Similarity Declaration

We, **Continental Automotive GmbH** hereby declare that:

The new version of our product Tire Pressure Monitoring Sensor , model number TIS-10DL, uses the same schematic, layout and the only differences are the slight change of the LF coil pads size, battery hole enlargement and introduces another supplier for the RF antenna, using the same material and Ni-coating layer.

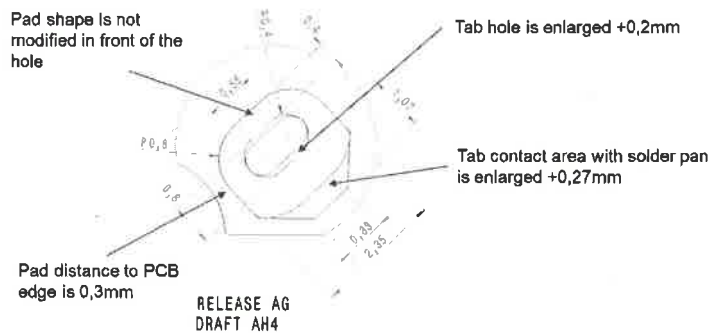
- Foot print update for LF coil – same location (updated dimensions for inner and outer length of the pads)

- Foot print update for battery hole;
